Letter of Response

Project Title: Lion Petroleum Convenience Store

Response to Fire Plan Review

Response to Plan Review

HVAC PLAN

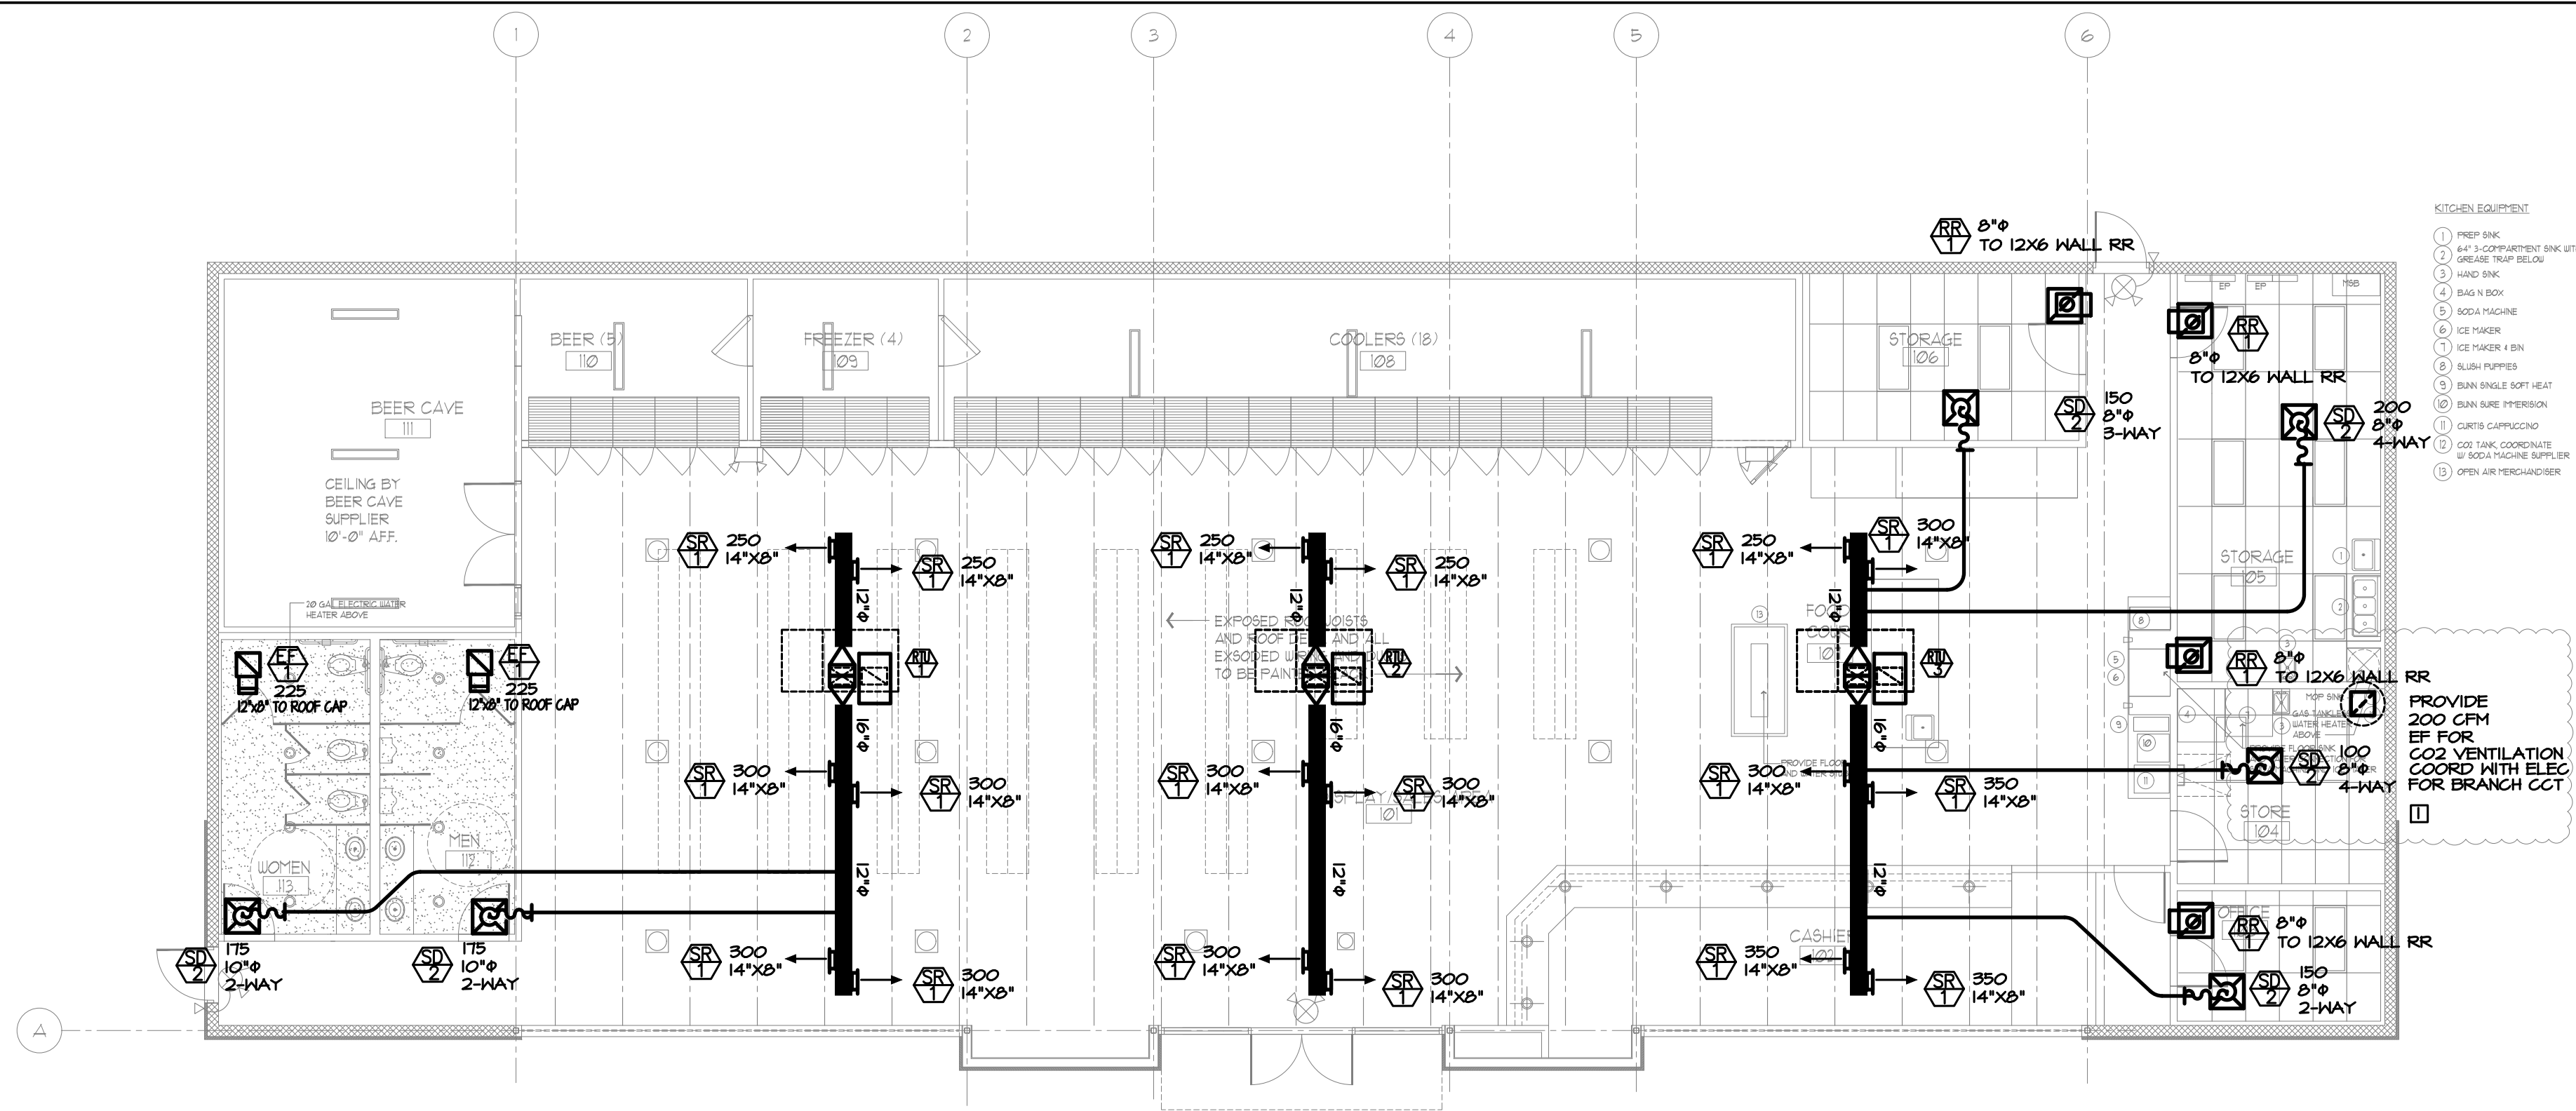
#5 See clouded area on equipment list next to enlarged kitchen plan. 3/A1 for size of CO2 tank and also see clouded area on M1 next to Store 104 where is CO2 located for Required ventilation per section 5004.3

ITEM 5 FROM JIM EDEN: ADDED EF ON TIMECLOCK ON SHEET M1

- ☐ CO2 VENTILATION FAN. DUCT 12"x8" TO 12" FROM FLOOR. PROVIDE AN ALARM SYSTEM TO DETECT OVER 5000 PPM CO2. PROVIDE AN EXTERIOR BELL AND A BELL IN ROOM FOR NOTIFICATION. ALARM SYSTEM SHALL HAVE A SENSOR IN ROOM WITH INDICATOR OF CO2.

H.V.A.C. ROOF PLAN

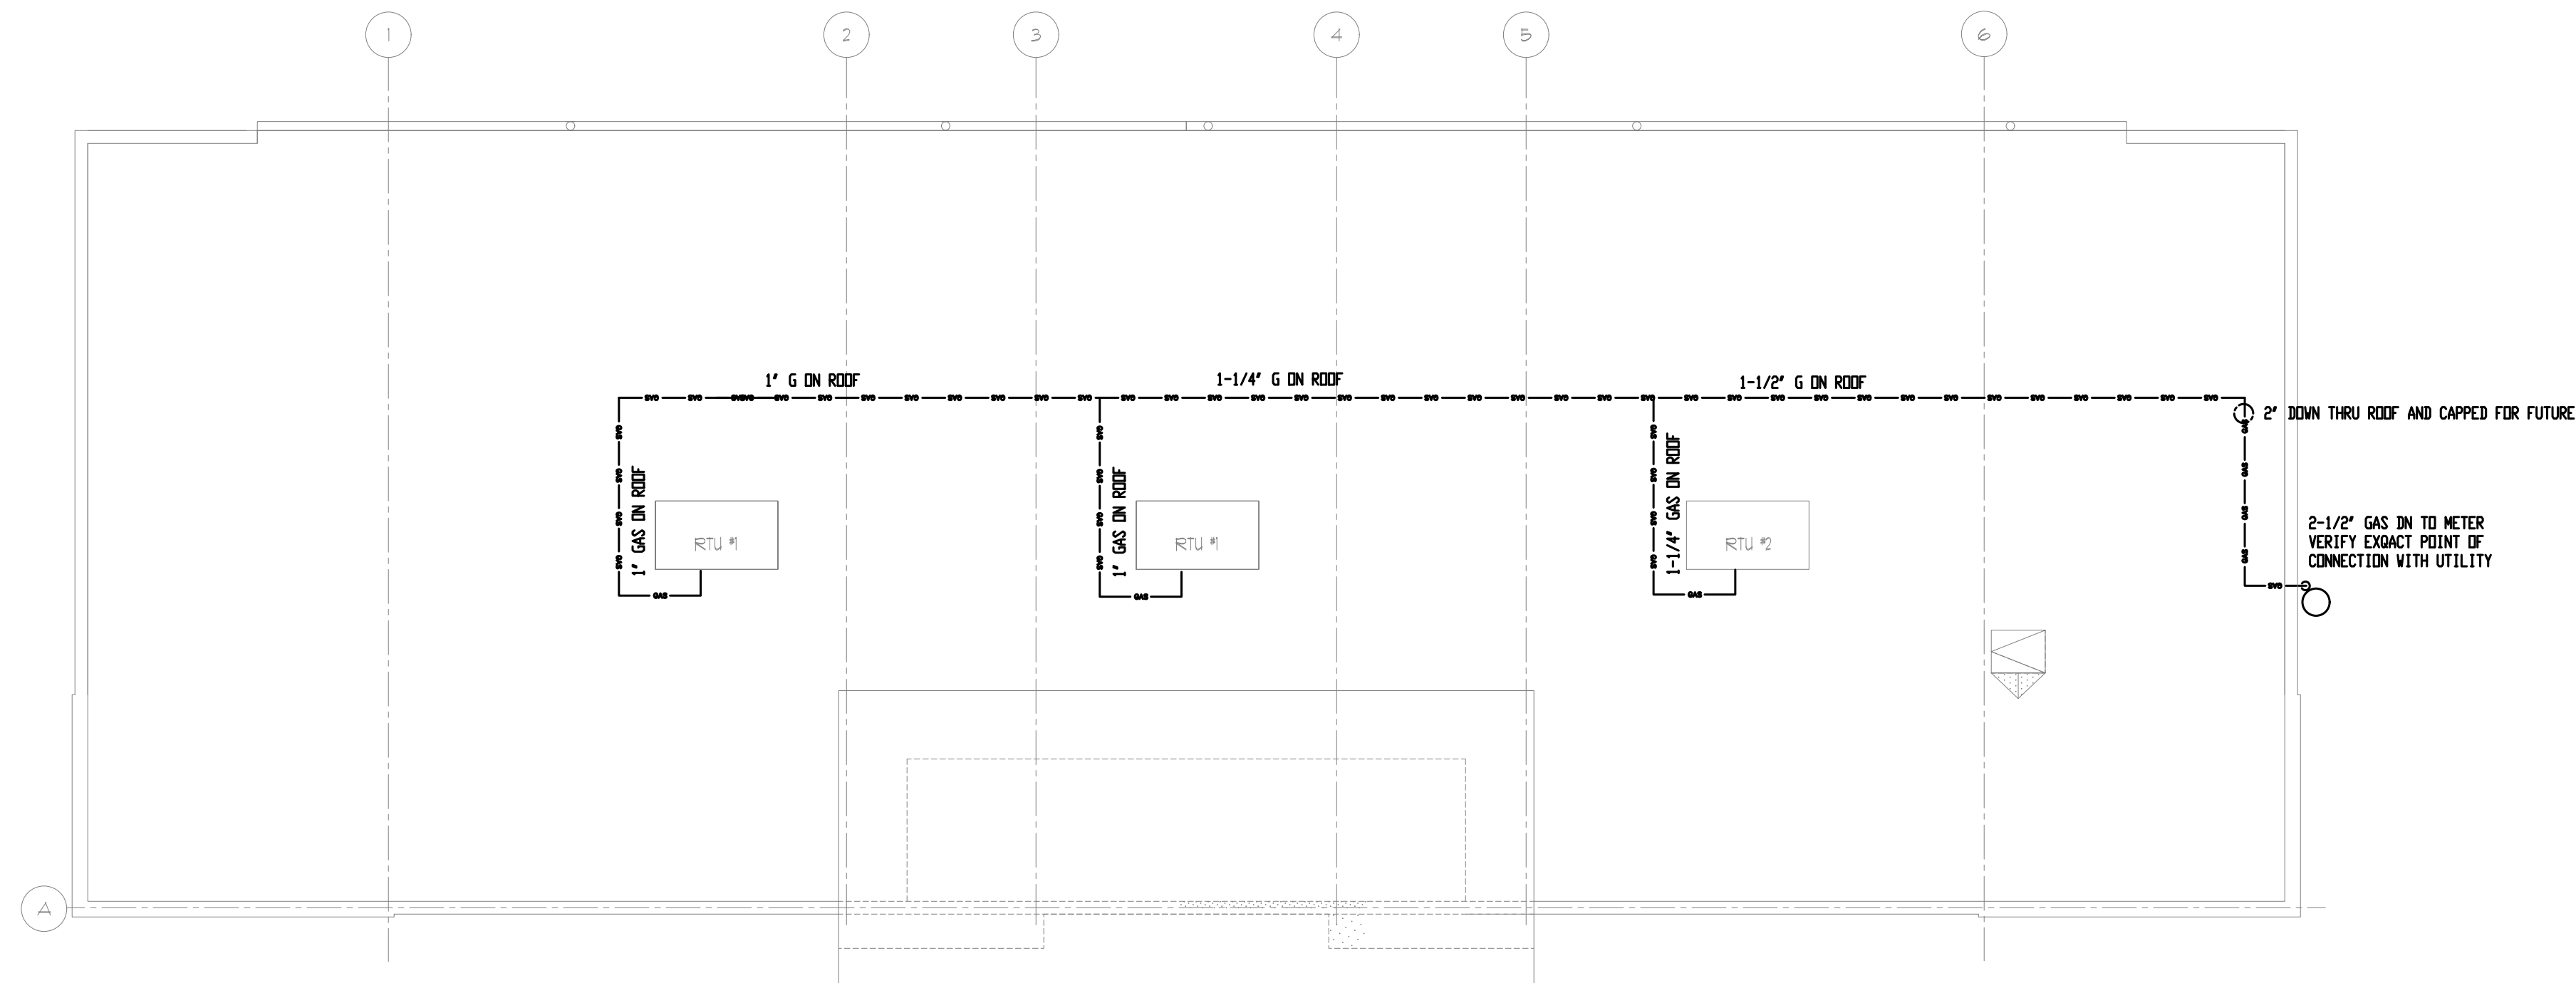
#8 Added explanatory note and code citation for smoke detectors, see clouded area at bottom of sheet M2.....

ITEM 8 FROM JIM EDEN: SMOKE DETECTORS ARE INCLUDED PER SHEET M-2 AND NO FIRE ALARM SYSTEM ARE INCLUDED

PROVIDE SMOKE DETECTORS WITH REMOTE ANNUNCIATORS FOR ALL 3 RTU AS PER NOTE 3 ABOVE AND PER IMC BELOW

P-1

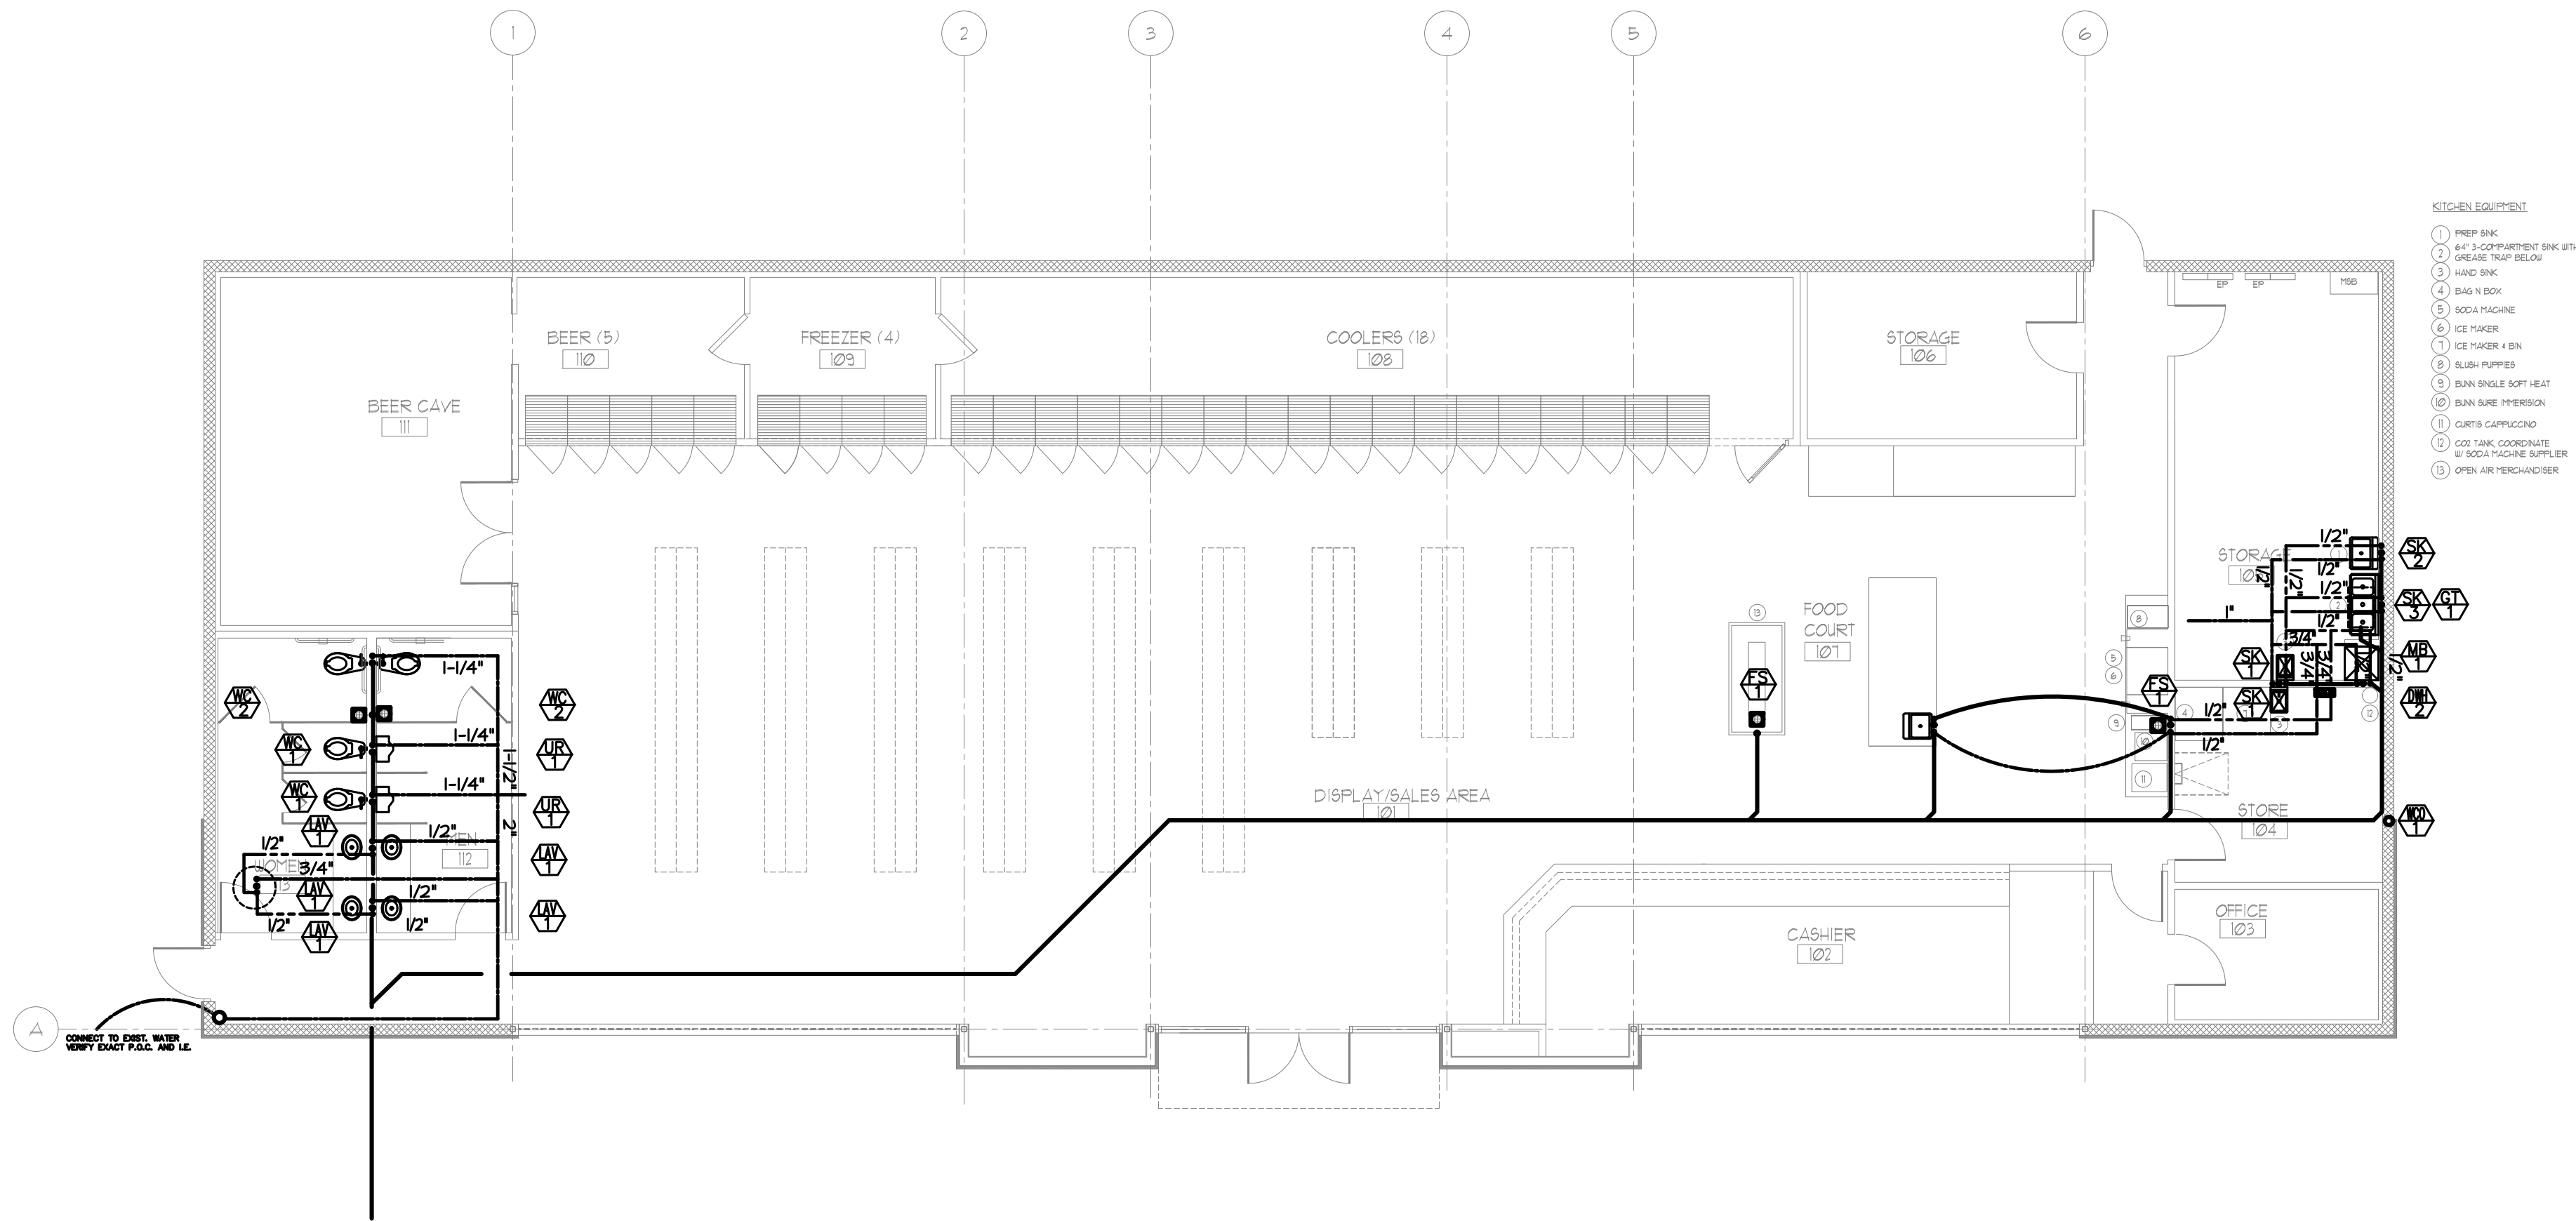
ITEM 6 FROM JOE FROSSE: TANK TYPE WATER CLOSETS SHALL HAVE FV LEVER ON ACCESSIBLE SIDE OF WATER CLOSET PR ICC ADDED NOTE TO SHEET P1.
